SUBJECT: OYSTER CREEK GENERATING STATION (OYSTER CREEK)  
OPERATING LICENSE NO. DPR-16  
DOCKET NO. 50-219  
RESPONSE TO REQUEST FOR ADDITIONAL INFORMATION -  
RADIOLOGICAL CONSEQUENCE ANALYSIS FOR CONTROL ROOM  
OPERATORS AT OYSTER CREEK GENERATING STATION  
(TAC NO. MA3465)

## **RESPONSE TO REQUEST FOR ADDITIONAL INFORMATION**

**Figure 1**  
**Integrated Aerosol Mass Leaked Out Through One Inboard MSIV**  
**(No Collection DF Being Applied)**

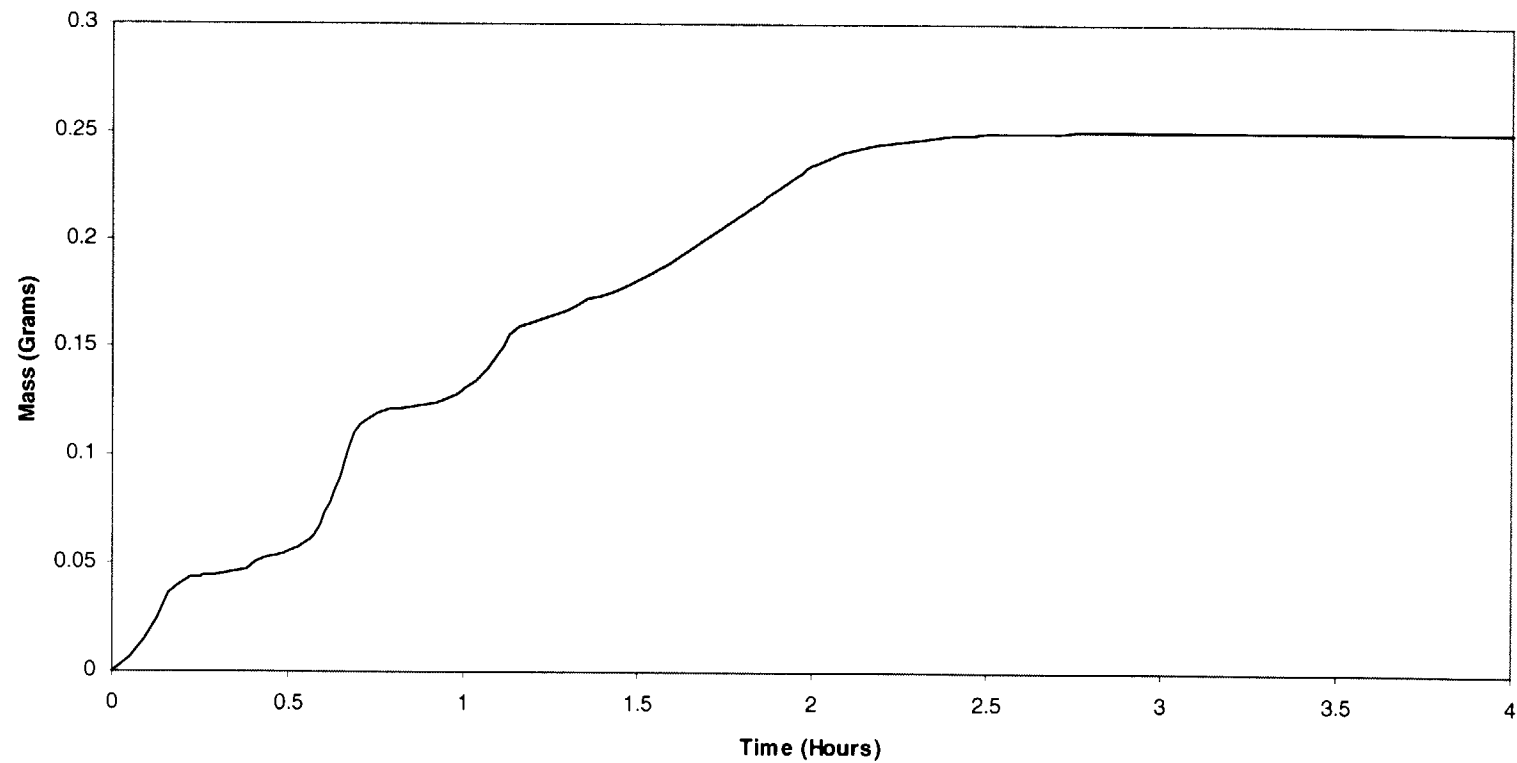
- Provide detailed technical justifications and references used for estimating aerosol impaction (decontamination factor of 2) at the inboard main steam isolation valve (MSIV) in the steam line with one open MSIV; and
- Describe in detail the STARNAUA model used for estimating aerosol sedimentation between the other steam line's closed MSIVs and provide the aerosol removal coefficients calculated with STARNAUA.

Using the above expression with the most conservative value for K, the leak path would be plugged when  $5.9\text{E-}3$  grams of aerosol has leaked through the single orifice. On Figure 1, which represents the mass leaked out through one MSIV as a function of time without plugging being considered, one can see that the total leaked mass per MSIV would be about 0.25 grams if plugging were neglected. Therefore, the actual effective DF due to leak path plugging would amount to about 40 (i.e.,  $0.25 \text{ grams}/0.0059 \text{ grams}$ ). It is noteworthy that the leak path would be plugged very early into the event, as  $5.9\text{E-}3$  grams of aerosol would have leaked through the hypothetical MSIV leak orifice in only 180 seconds.

The effect of plugging would be greater than just a DF for the aerosol release; it might actually affect the rate of gaseous iodine and noble gas release, as well. These effects are ignored, however. Instead, only a DF of two on the aerosol (and on the elemental iodine which is assumed to be adsorbed on the aerosol is credited (Reference response to NRC Question No. 4).
